RESPONSE TO REQUEST FOR ADDITIONAL INFORMATION

APR1400 Design Certification

Docket No. 52-046

RAI No.: 100-8008
SRP Section: 09.05.06 – Emergency Diesel Engine Starting System
Application Section: 9.5.6
Date of RAI Issue: 07/22/2015

Figure 9.5.6-1 Emergency Diesel Engine Starting Air System Flow Diagram

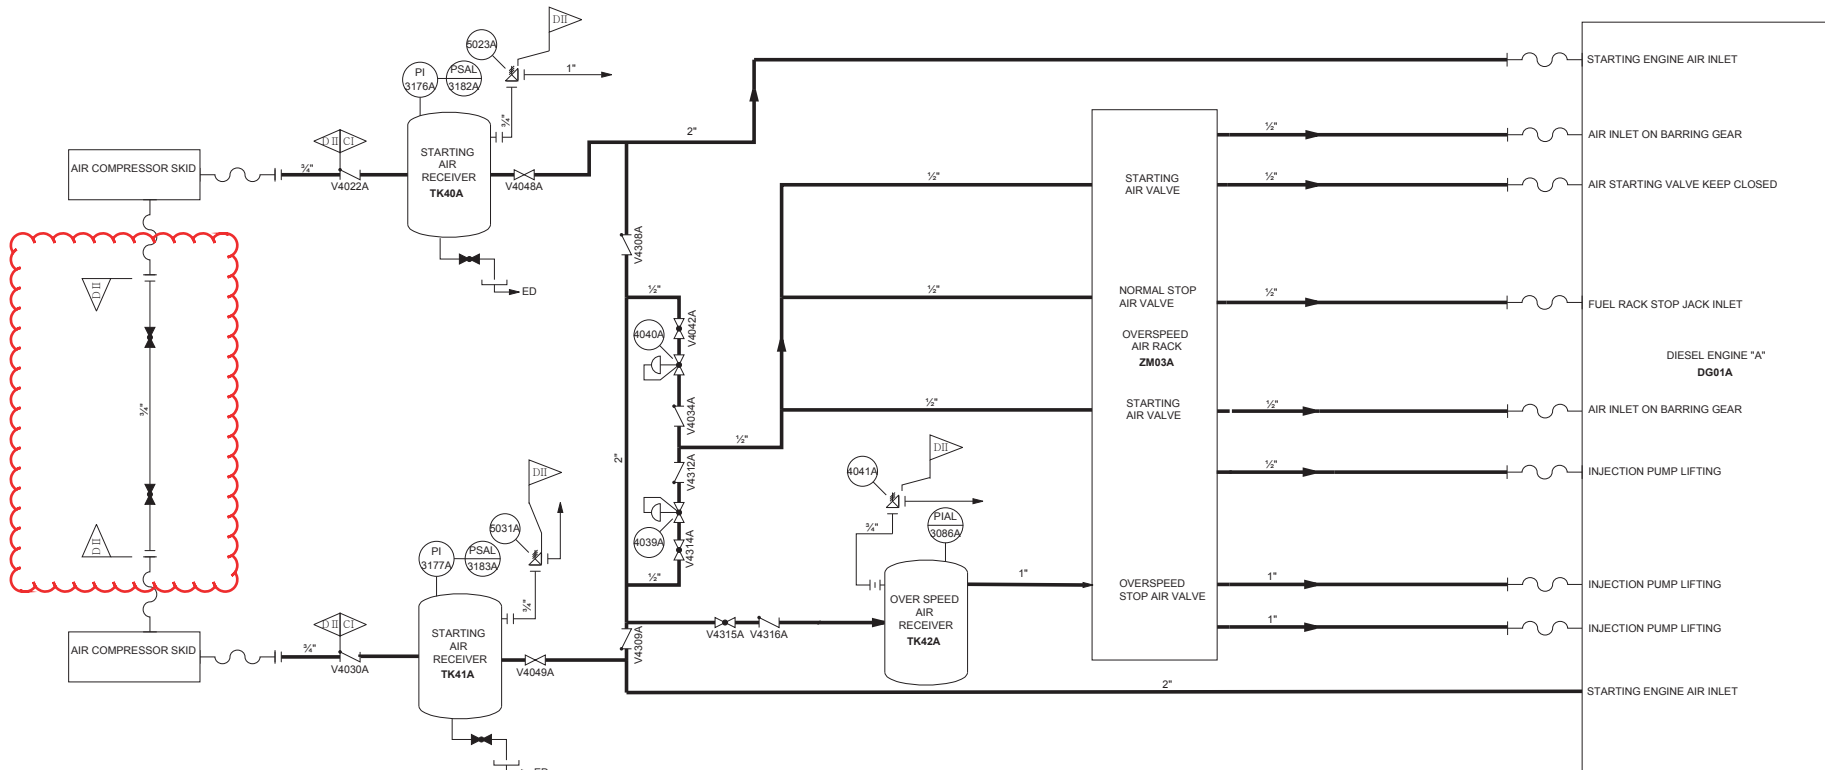
Figure 9.5.6-1 shows the cross-connecting line, but does not show any normally closed valve to isolate the redundant starting air systems.

The applicant is requested to provide the description and location of the normally closed valve and update figure accordingly.

The cross-connecting line with normally closed valves is located in the motor-driven compressor package. This cross-connecting line is marked on the attached markup, page 1 of 2.

Figure 2.6.2-1 Emergency Diesel Generator Mechanical System

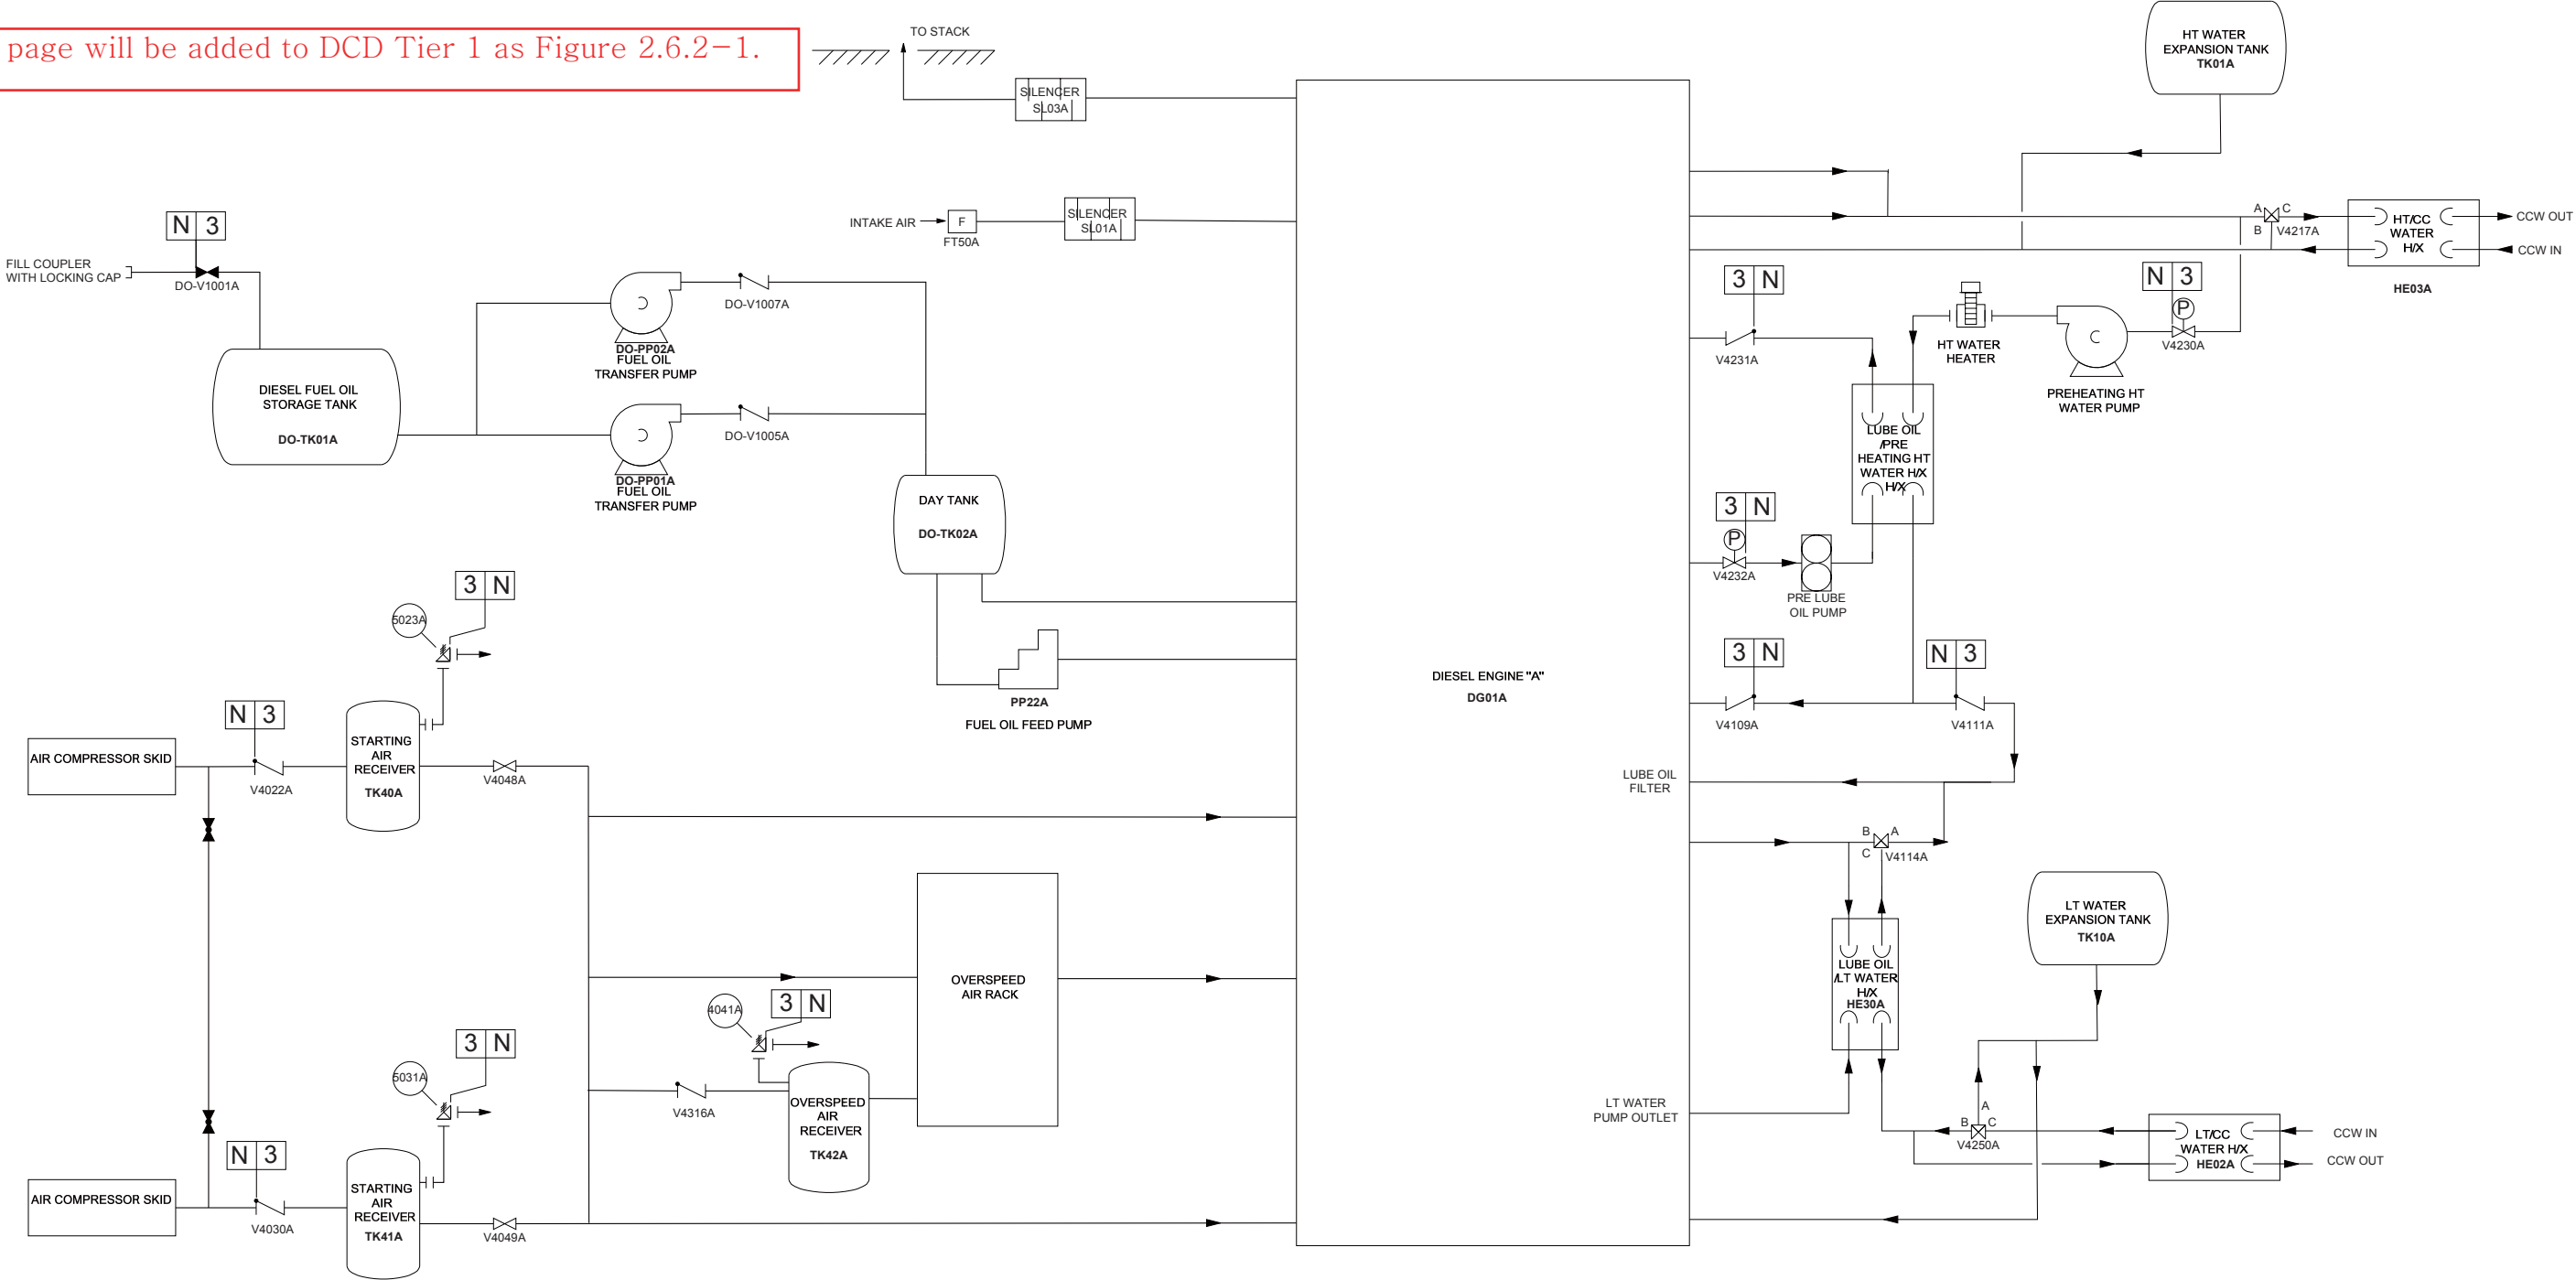
The staff finds that Tier 1 information does not include any figures for the safety-related EDG support systems to accompany the ITAAC to verify as-built functional arrangement. Also, Tier 2 contains flow diagrams in Section 9.5 and these details are not consistent with these Tier 1 tables.

The applicant is requested to consider adding support system diagrams to Tier 1 information in order to properly address ITAAC, as well as making Tier 2 Section 9.5 information consistent with corresponding Tier 1 information. (This RAI also applies to other EDG support system Section 9.5.4, 9.5.5, 9.5.7, and 9.5.8)

The figure on the EDG mechanical system will be added to DCD Tier 1 as Figure 2.6.2-1.

This page will be added to DCD Tier 1 as Figure 2.6.2-1.
